Smith Ranch - Highland
Uranium Project
P. O. Box 1210
Glenrock, Wyoming USA 82637
Casper: 307-235-1628
Douglas: 307-358-6541
Fax: 307-358-4533

RE: Response to Request for Additional Information Concerning Satellite SR-2.
Source Materials License SUA-1548, Docket No: 40-8964 (TAC No. J00504)

FIGURE 1

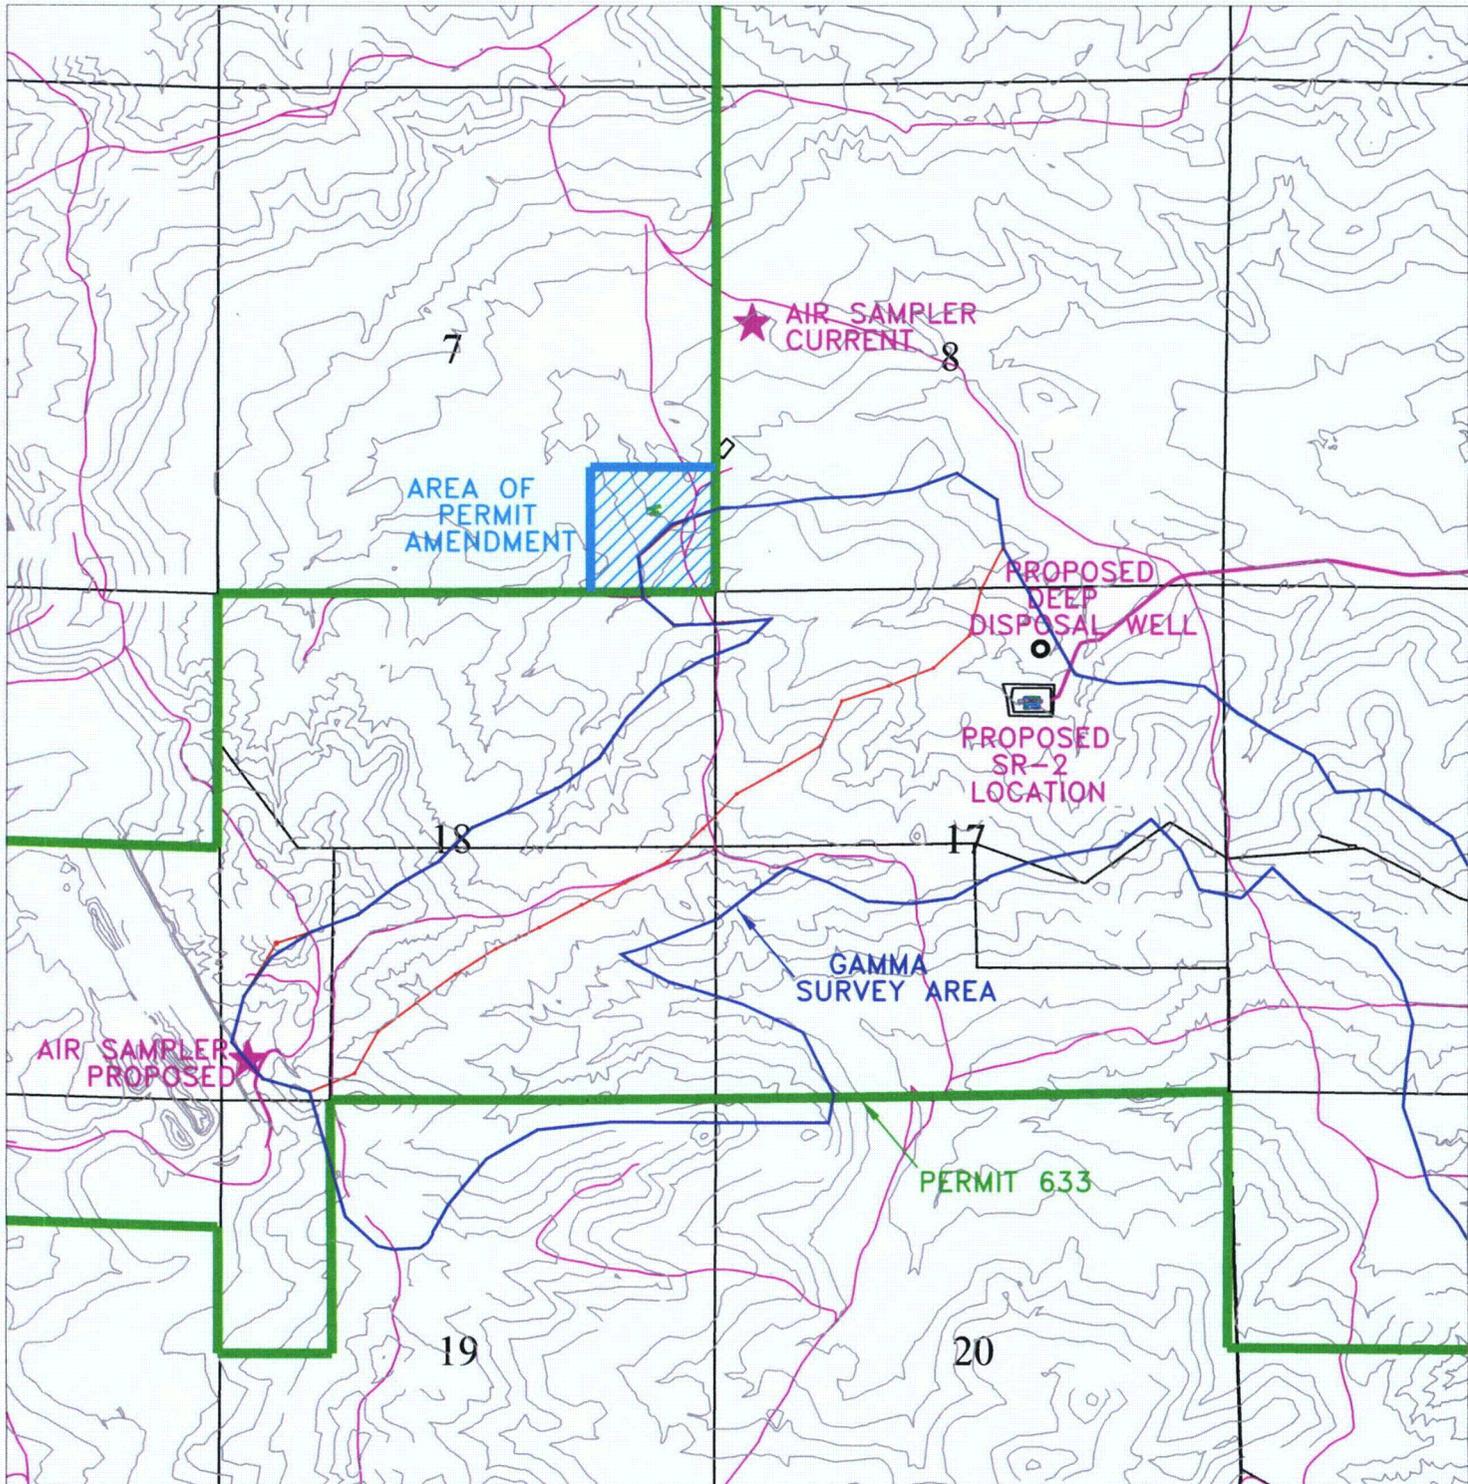
1. *Volume I, Sections 5.3.2 and 5.3.3 of the Reynolds Ranch Amendment submittal identify the six "Air Monitoring Stations" that are part of the SR-HUP and Reynolds Ranch continuous air monitoring program and discusses Passive Radon Gas Monitoring. Please describe how the present air monitoring program configuration accounts for emissions (including radon gas) from Smith Ranch-Highland Uranium Project (SR-HUP) In-Situ Leach (ISL) Satellite SR-2. In addition, Air Station No. 1, which reportedly monitors background conditions, is located approximately 4,000 feet northwest of the proposed location for SR-2. Please describe the expected impact, if any, SR-HUP ISL Satellite SR-2 will have on monitoring results (including passive radon gas monitoring) from Air Station No. 1.*

2. *Deep disposal wells for liquid effluents from SR-HUP Central Processing Plant (CPP), SR-1, Highland facility, and Reynolds Ranch Satellite (proposed) are discussed in Volume I, Section 4.2.1 of the Reynolds Ranch Amendment submittal: however, liquid effluent disposal for SR-HUP ISL Satellite SR-2 is not identified. Please describe how liquid effluent disposal will be addressed at SR-2.*

The existing Air Station No. 1 located in SW1/4 NW1/4 Section 8, T. 35 N, R. 74 W. will be relocated to the extreme southwestern edge of the monitor well ring, SW1/4 SW1/4, Section 18, T.35N. R. 75W, associated with construction of the first wellfield, Mine Unit 9. The station will be moved when power is available to the monitor wells in the area of the proposed Air Station No. 1. This new location will provide PRI with an upwind or background location for

PRI is in the process of applying for a Class I Injection Well in the Southwest area, specifically NW1/4 NE1/4 Section 17 T. 35N. R. 74 W. The application will be submitted during December, 2006. The new well will be designated SR-2 and will dispose of liquid effluents from the proposed satellite.

Please find attached Figure I showing the location of PRI's proposed Air Sampling Station, Deep Disposal Well, area of permit amendment and Satellite SR-2. Please contact me if you have any questions at (307) 358-6541, ext. 46.
